802.1Qbp – ECMP Bridge Model 2/9/2012

ECMP Model Discussion Points

Not all VLANs use the enhanced service:

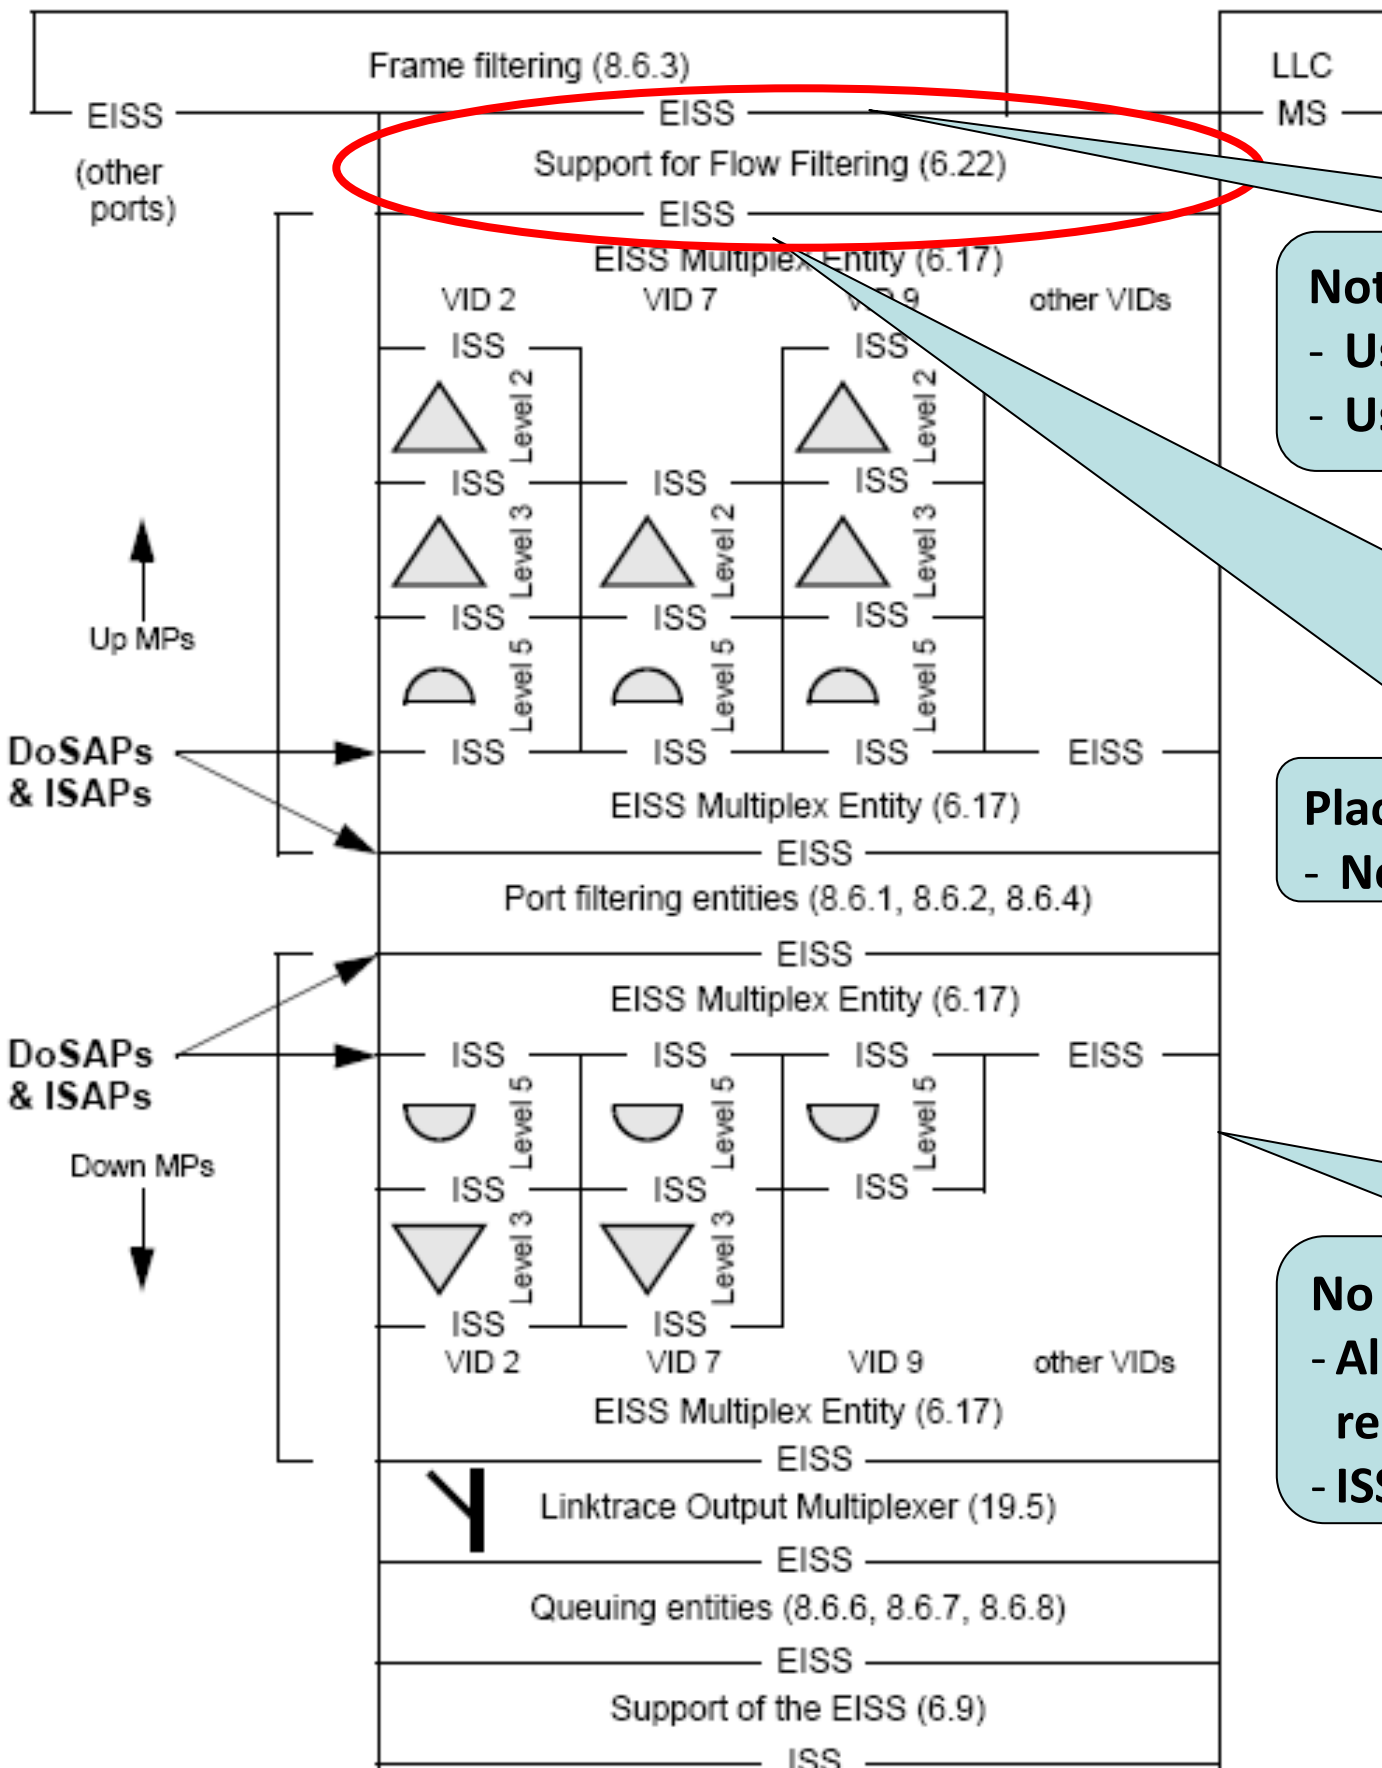
- Use one SAP at the top or two?
- Use one Frame filtering function or two?

- Do all the shims above the tag processing need to be extended to support a new SAP type?
- It was agreed that this ISS did not have to include the new parameters; however, if MPs use ISS then there is no other way to pass new info up/down.

Placing Flow Filtering shim with CBP shim:

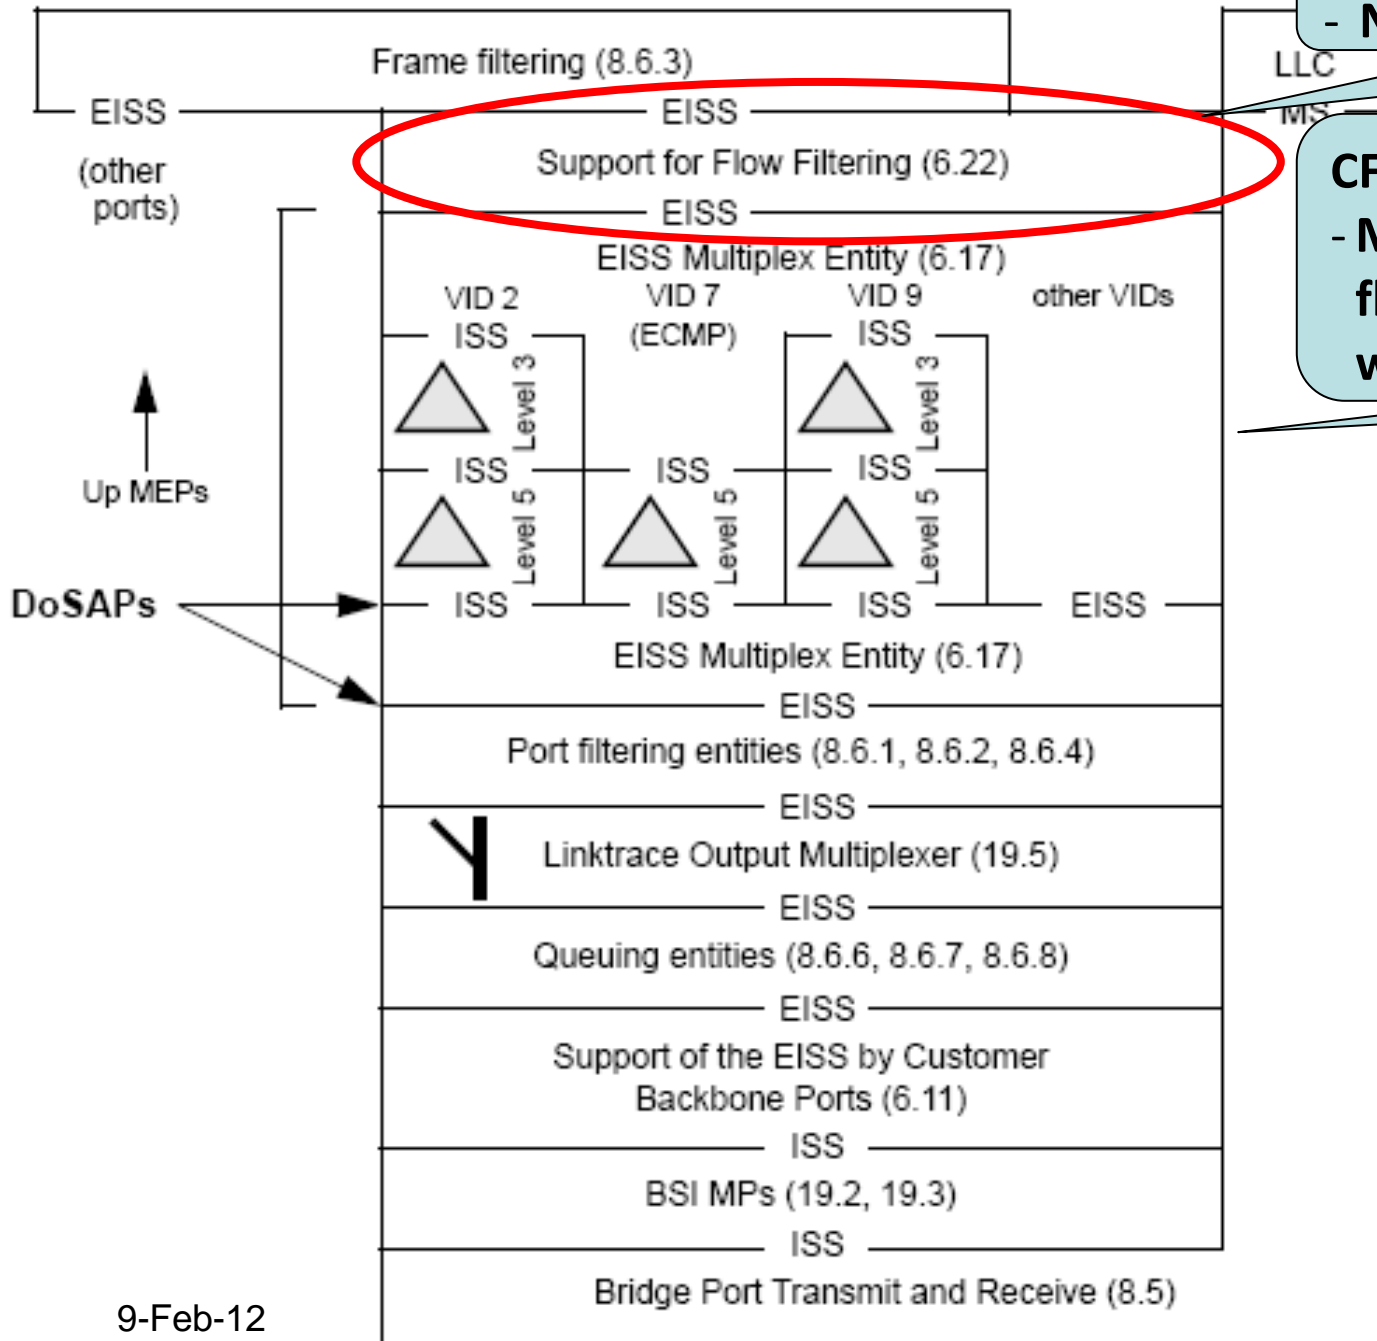
- Keeps all tag processing together

CFM impact:
 - MEPs generate CFM frames with or without flow_hash and time_to_live (depending on whether the VLAN is using ECMP).

Placing Flow Filtering shim with VLAN tag shim:

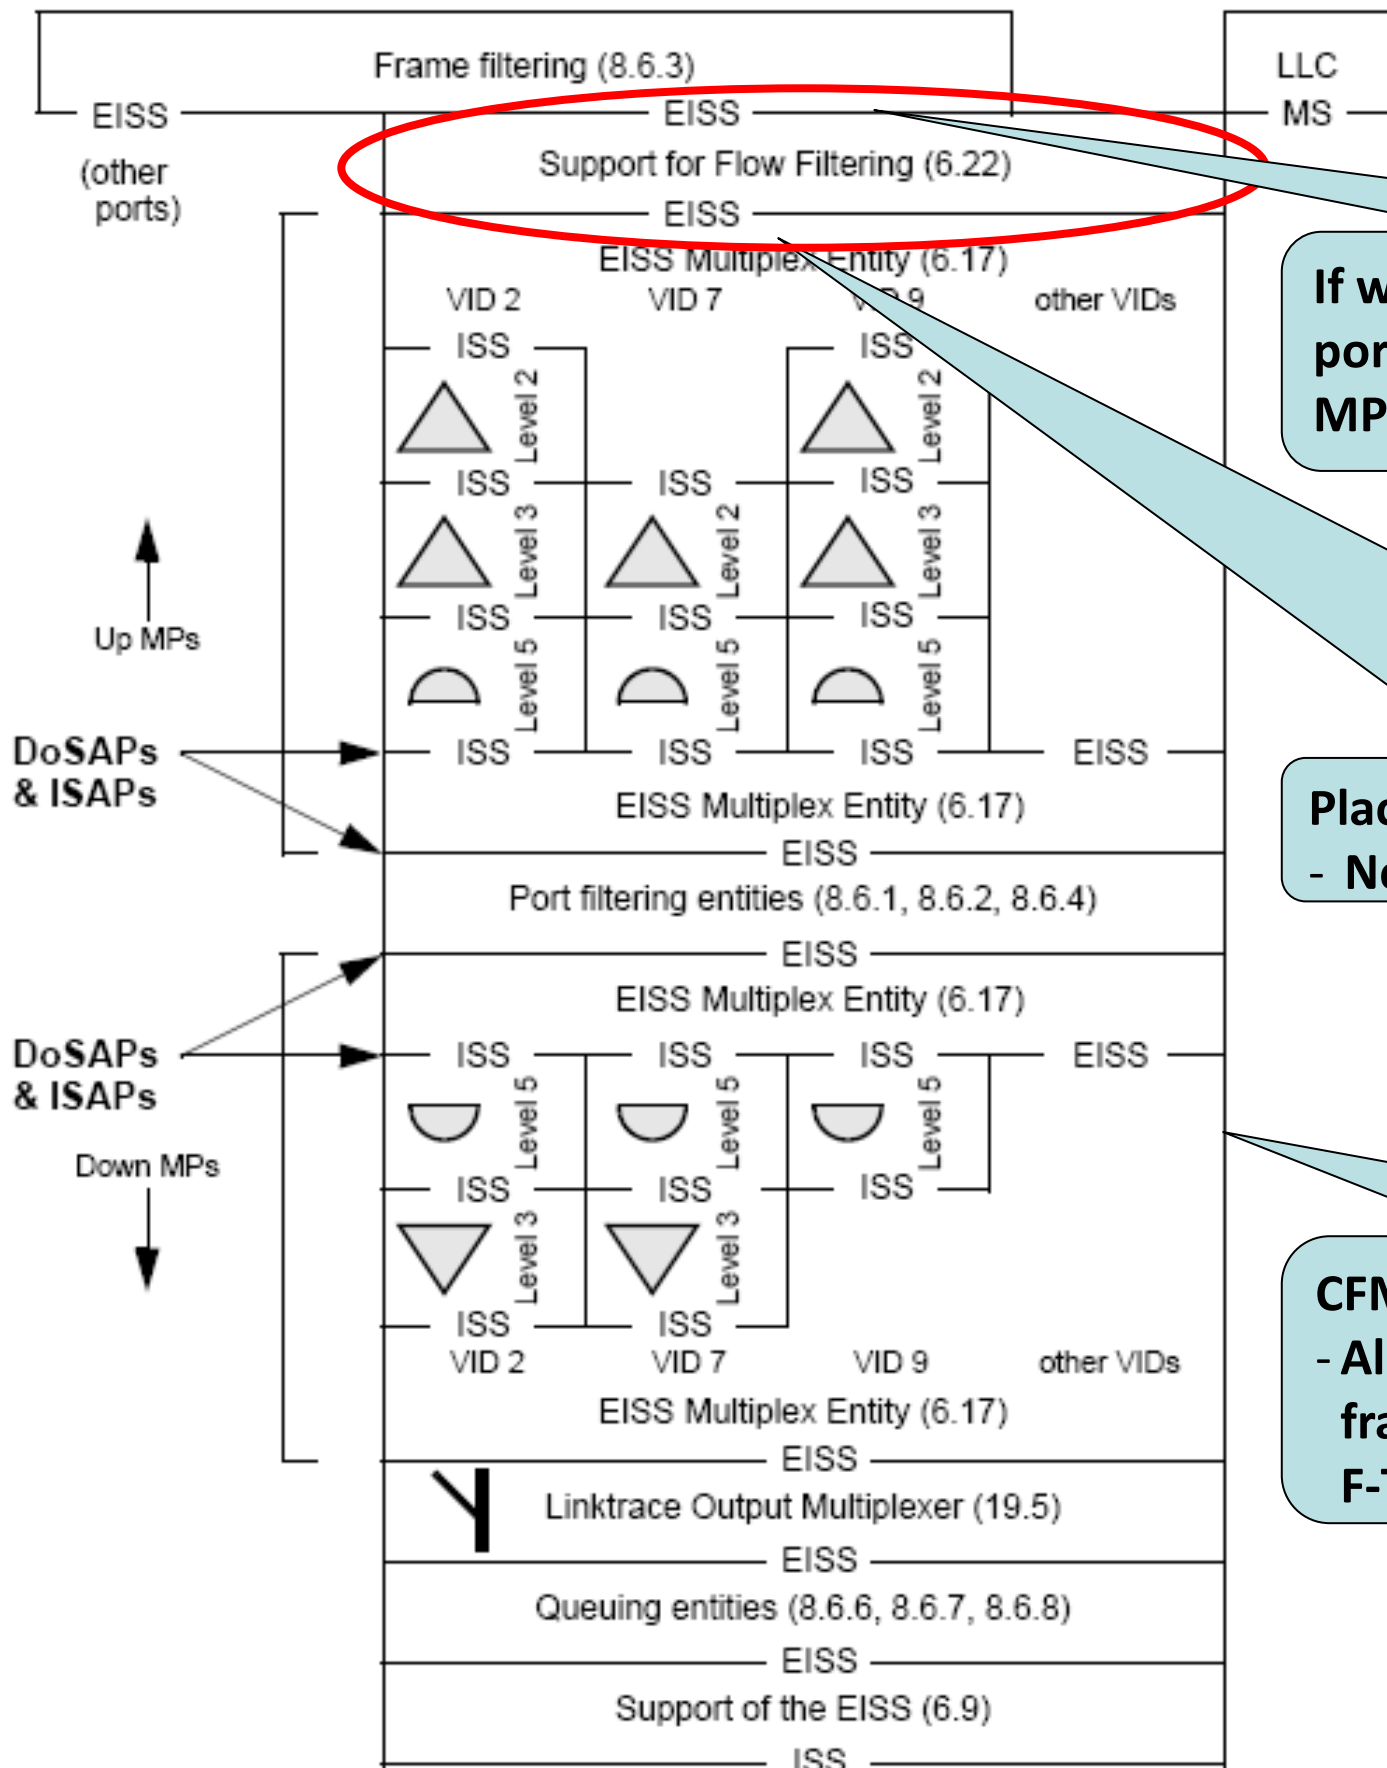
- Keeps all tag processing together
- Could have used one tag to carry all info

If we need new CFM functions on intermediate ports, do we need a new set of VID mux/demux and MPs? Flow Hash mux/demux?

Flow-Level CFM (from bp-sajassi-cfm-0711-v01.pdf)

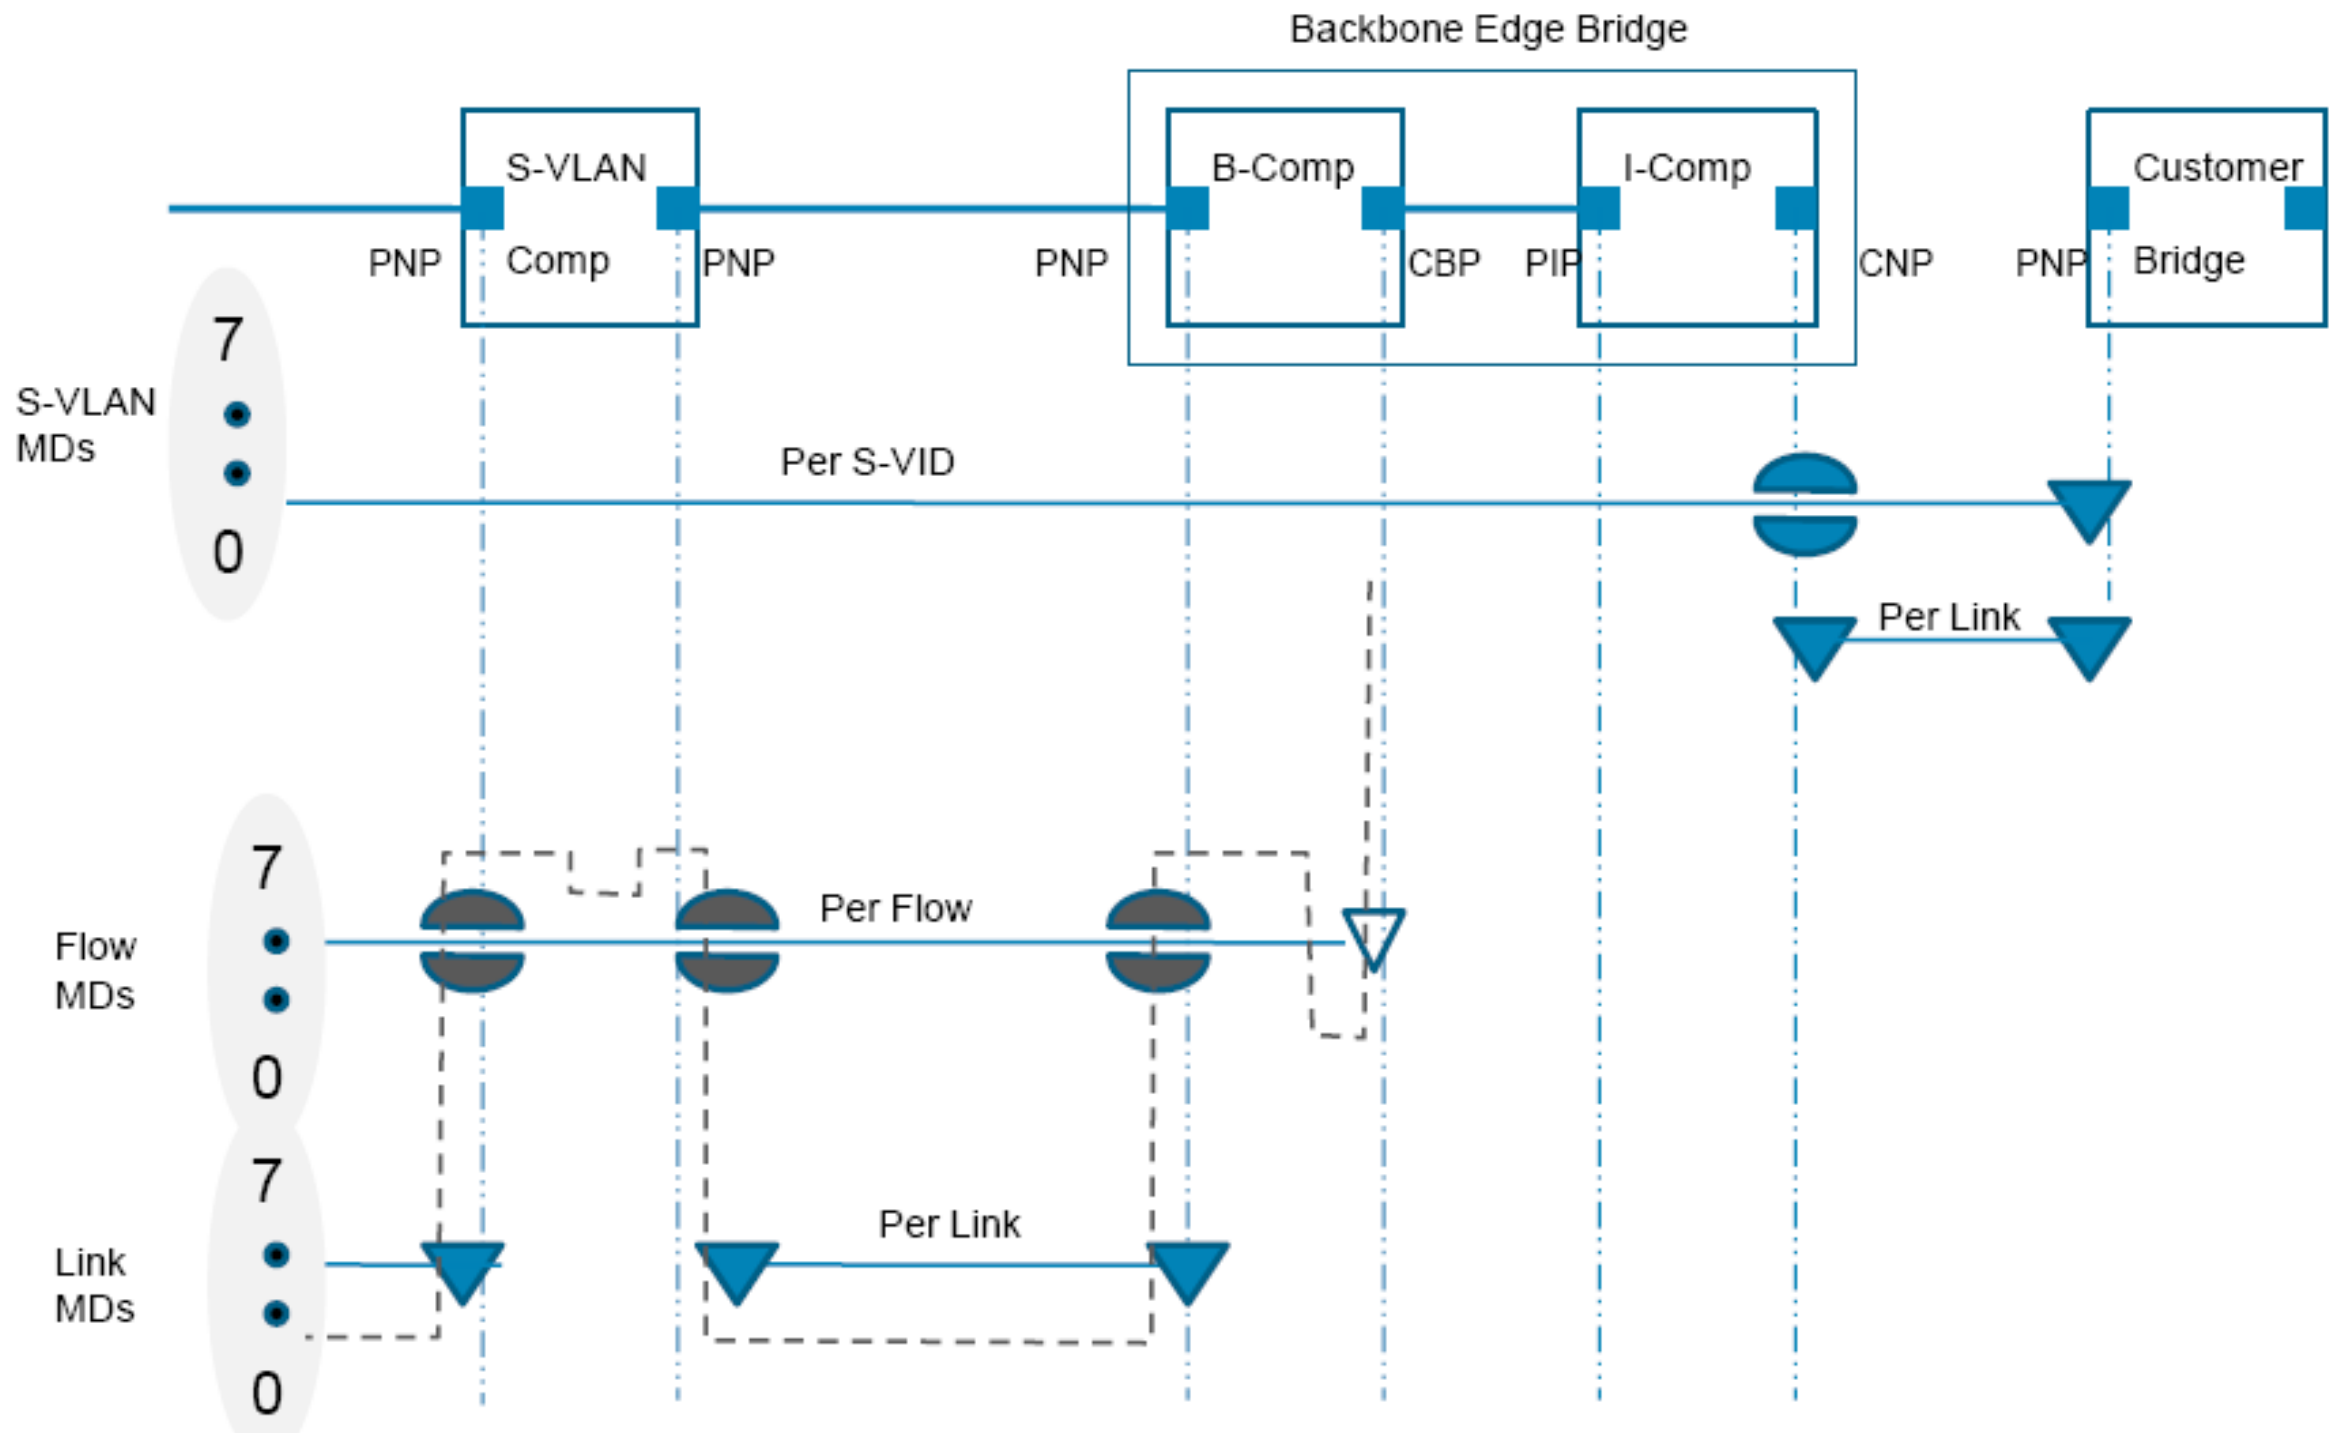
- This looks like Network CFM, but
 - in the B-VLAN carrying the service
 - using DA and Flow Hash selected to cover service paths
